Answers to Reviewer Questions

Charge build up

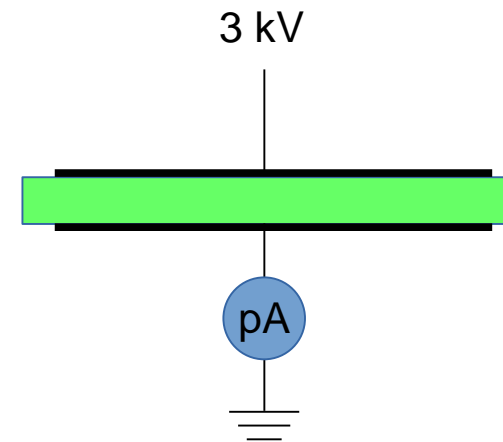
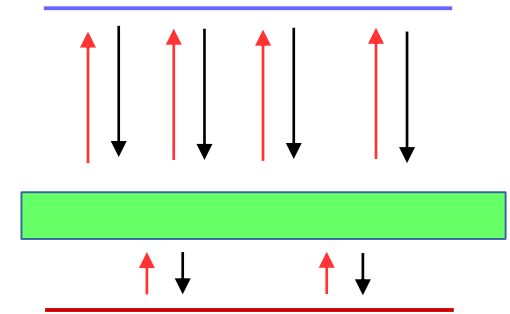
- The committee has pointed out several times the concern of unknown field in regions where insulators such as G10/FR4/FRP, that can charge up, are used in the vicinity of high field regions. Can you review and tell us the current knowledge and positive experiences from other experiments, detectors, lab tests? Will this issue be still tested in the 35ton test?
 - Answered

- FEA with “zero perpendicular field” boundary condition on all surfaces of the I-beams except at top and bottom.
- This is the condition when surfaces have charged just enough to repel any further incoming charge.
- White contour lines: V
- Black contour lines: E
- High fields at corners.
- Charge-up rate depends on volume adjacent to surface.

- Charging of two sides can be asymmetric if volume on one side is different from the other.
- E.g., for box beams holding field cages, roughly 20 pA/m² on one side, 30 pA/m² on the other.
- Approximate analytic calculation gives **~2 day** time constant to charge one side only if no current on other side, **~2 wks** for both sides to charge, for 1/4" thick material.
- **A non-infinite bulk resistance would mitigate charging:** internal $E = J \rho$.
- E.g., if $\rho = 10^{18}$ ohm-cm, then
- $E < (30 \text{ pA/m}^2) (10^{16} \text{ ohm-m}) = 3000 \text{ V/cm}$.
- Attempted to measure resistivity of 12" x 12" x 1/4" FRP plates at K-State at $E = 4.7 \text{ kV/cm}$. Saw long, increasing time constants of hours then days, slow "self-recharge" after applied voltage zeroed or reversed. Done in air at room temp.
- **Need test at full HV and E scale, in LAr.**

Conductive Caps with PE Edge

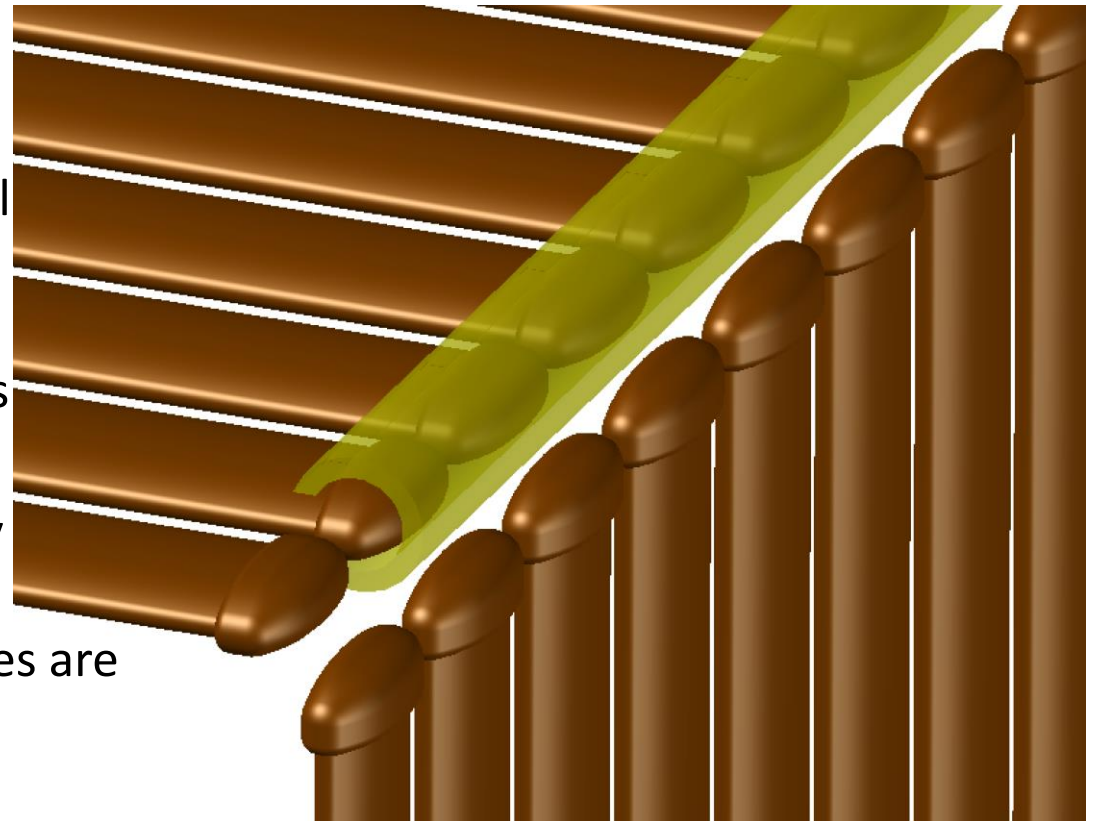
- Have the project discussed alternative designs to the profile caps of the FC AI profiles? The committee believes these parts may pose a significant risk if they degrade.

- UHMW PE is the material used in nearly all cryogenic HV feedthroughs.
- The caps are expected to shrink $\sim 2\%$ in LAr. This is accounted for in the opening of the caps. No significant stress is expected from the attachment of the caps to the profiles
- The caps are locked onto the profiles with two nylon rivets. The locking of the cap is tested in LN2 with $\sim 14\text{kg}$ of pulling force (force gauge limit)
- Since the small higher field test was successful, we are fairly confident that we have a viable solution and have not discussed alternatives.
 - But, other interesting configurations are available

- Caps (plugs) are 3mm thicker than the profiles.
- Max E: 29.5kV/cm
- CNC or casted metal plug screwed into the profile ends

- The exposed caps/plugs would allow direct arcing across the caps to adjacent FC modules in a discharge.
- To achieve HV isolation, we can encase the caps in a polyethylene tube (with one side slotted). This tube should be locked on the CPA side, and allow shrink on the APA side.
- The tube length does not need to exceed 2m.
- With this scheme, the metal electrodes is safe during normal operation without the PE tube. The tube helps to maintain HV isolation.
- If the tube is damaged, only this gap can arc through, while the rest of the modules are still protected.

2cm Gap between Modules

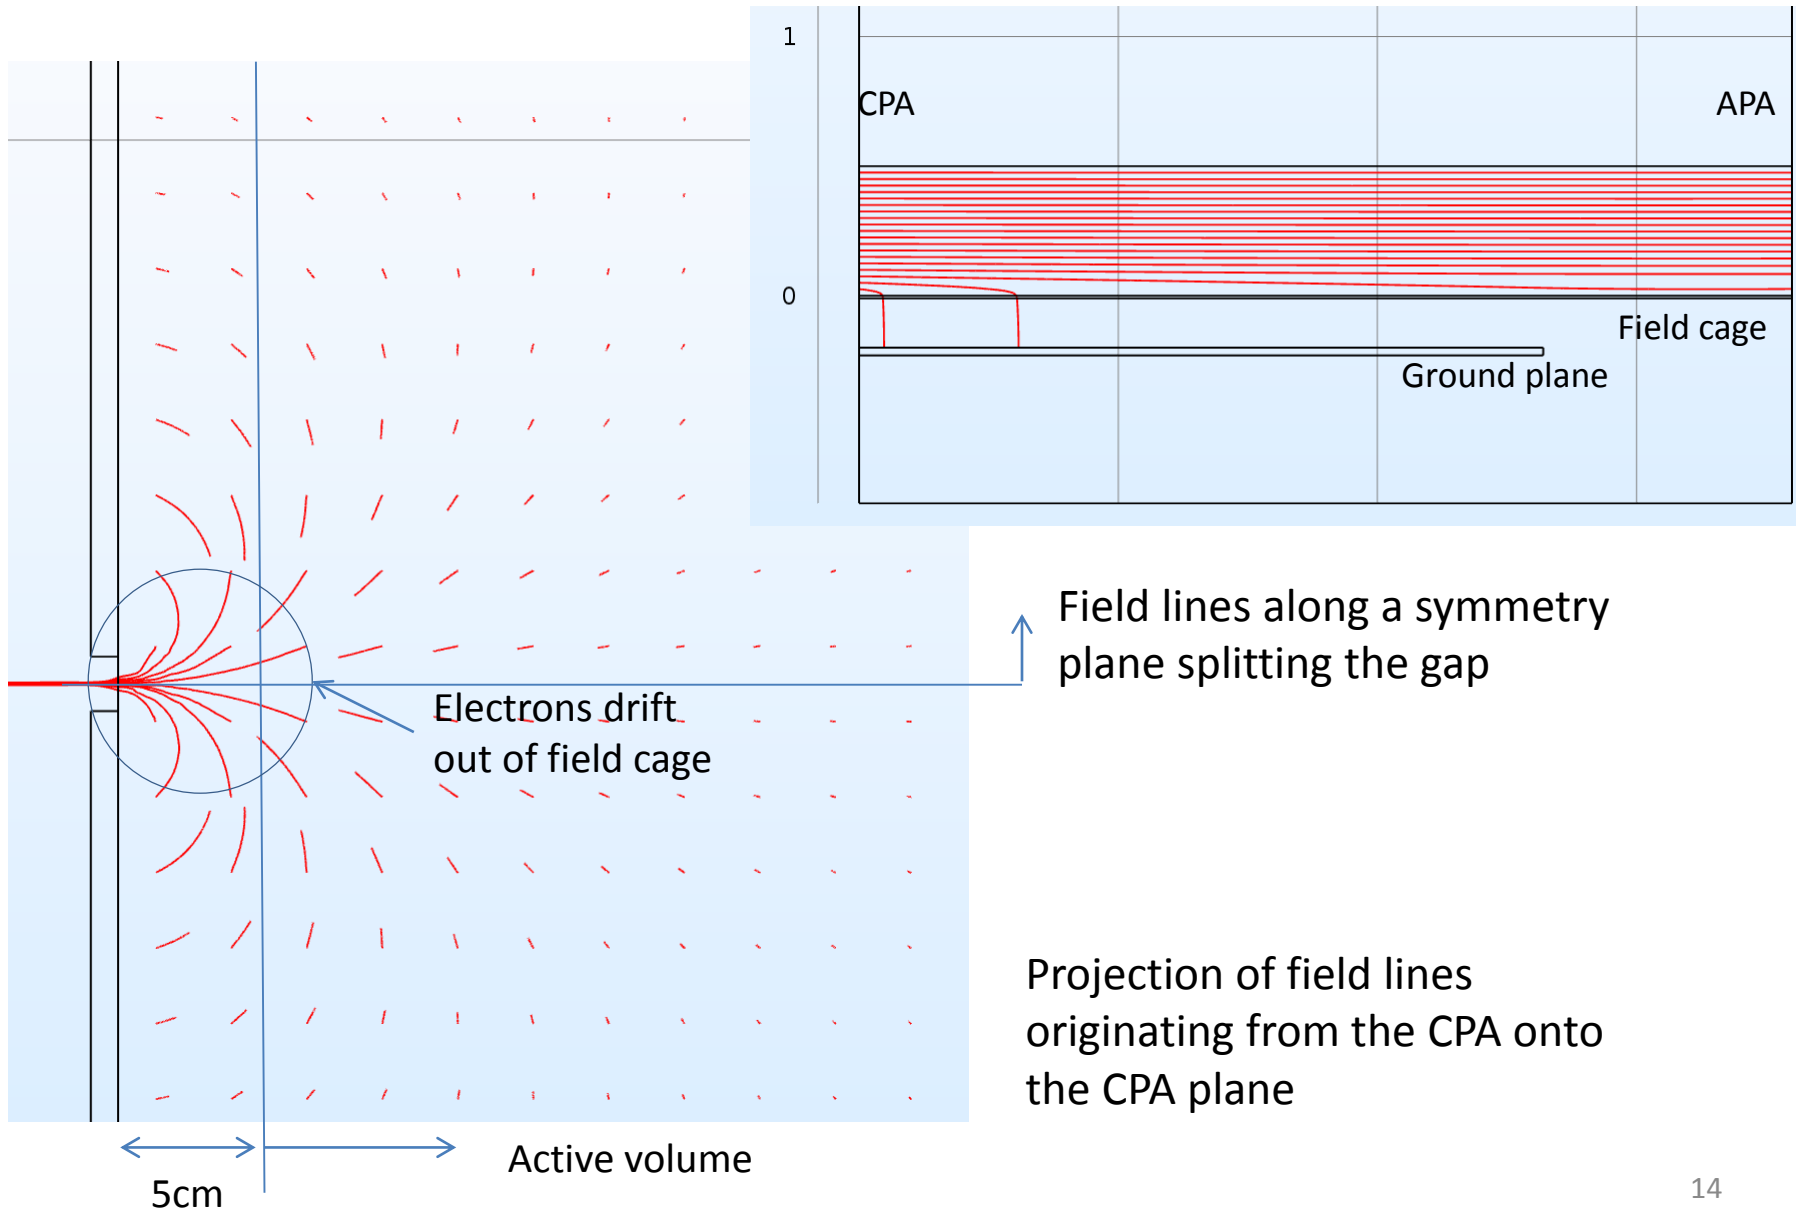
- The mechanical properties of the proposed FC Aluminum profiles are well defined. Can you show the mechanical requirements (alignment, planarity, etc) when they are together in assembled panels, and when adjacent panels are joined together? Is there a value of how possible deformations after assembly will affect the electric field?
